## APPLICATION FOR APPROVAL OF CONSTRUCTION CHANGE DOCUMENT – CCD CATEGORY A

School District/Owner: Davis Joint Unified School District	DSA File #: 57	- 11
Project Name/School: R.W. Emerson Jr. H. S. / Da Vinci Charter School	DSA App. #: 02	- 114292

Brief description of construction change (attach additional sheets if needed):  
Remove and replace four existing skylights on existing curb.

R.W. EMERSON JR. HIGH SCHOOL /  
DA VINCI CHARTER SCHOOL  
DAVIS JOINT USD  
RE-ROOFING

Drawing Title: **OVERALL ROOF PLAN**  
**BLDG A**

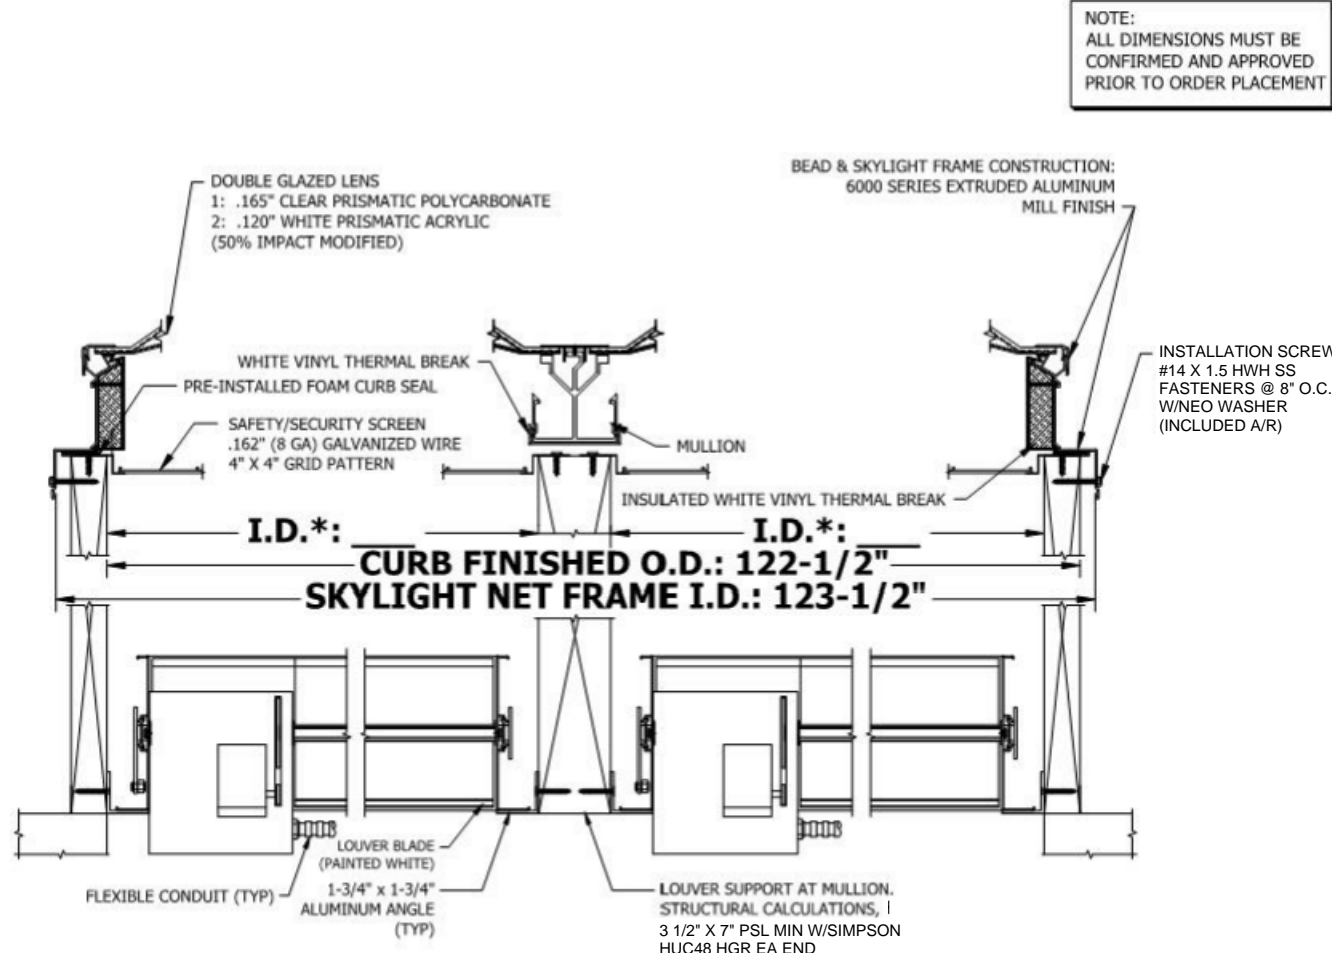
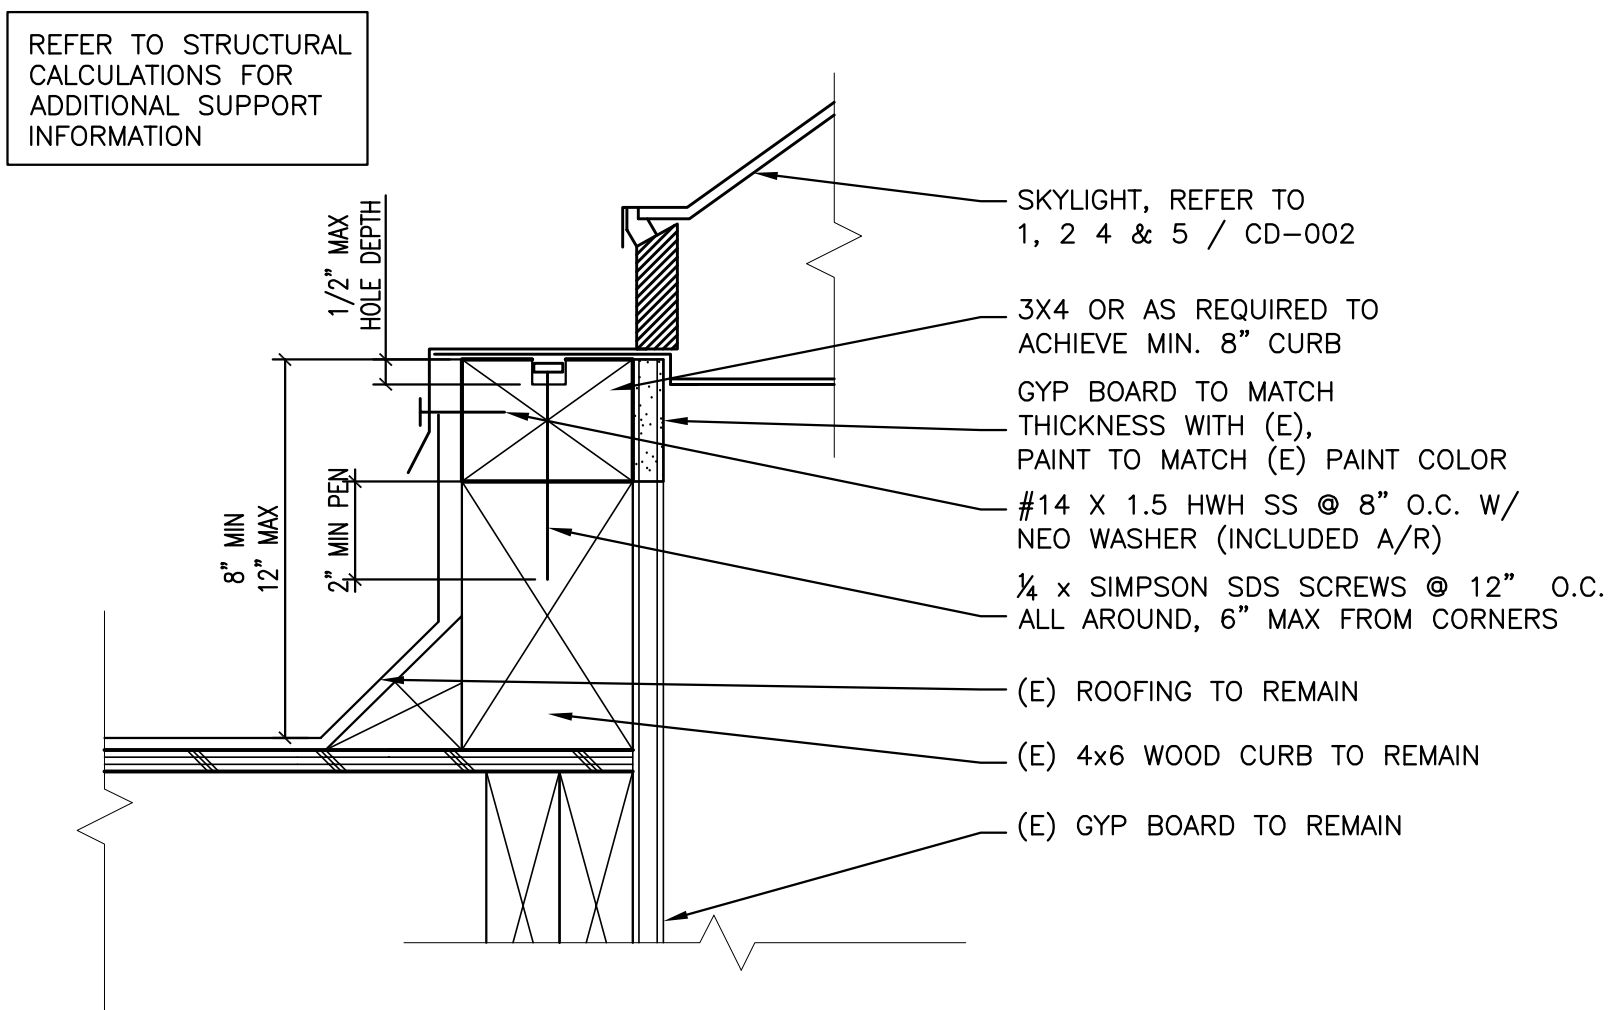
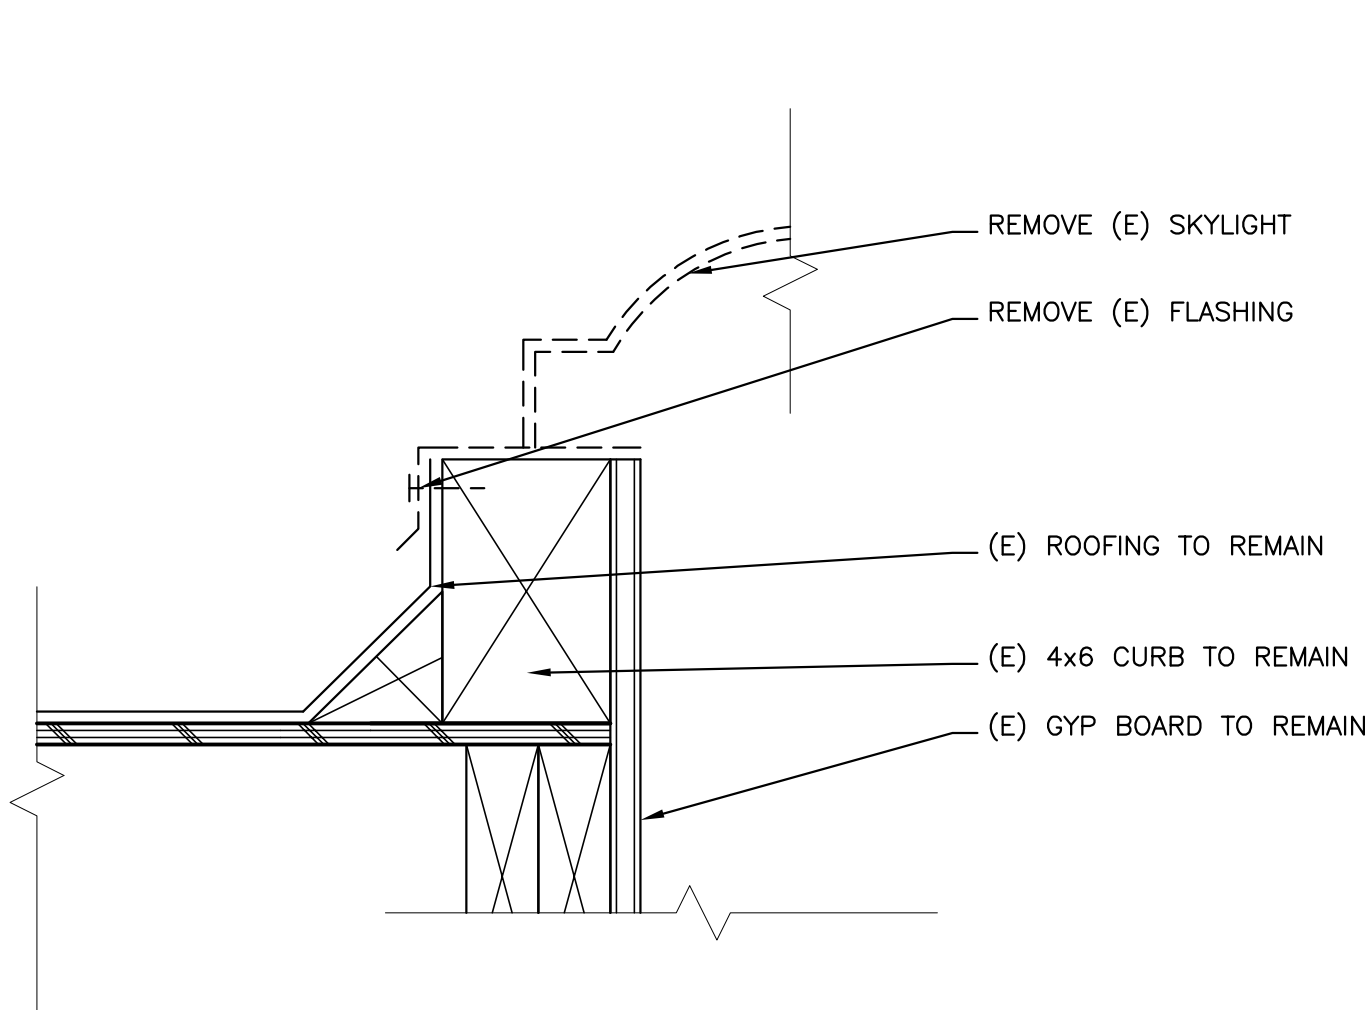
List of DSA approved drawings affected by this CCD: A4.1
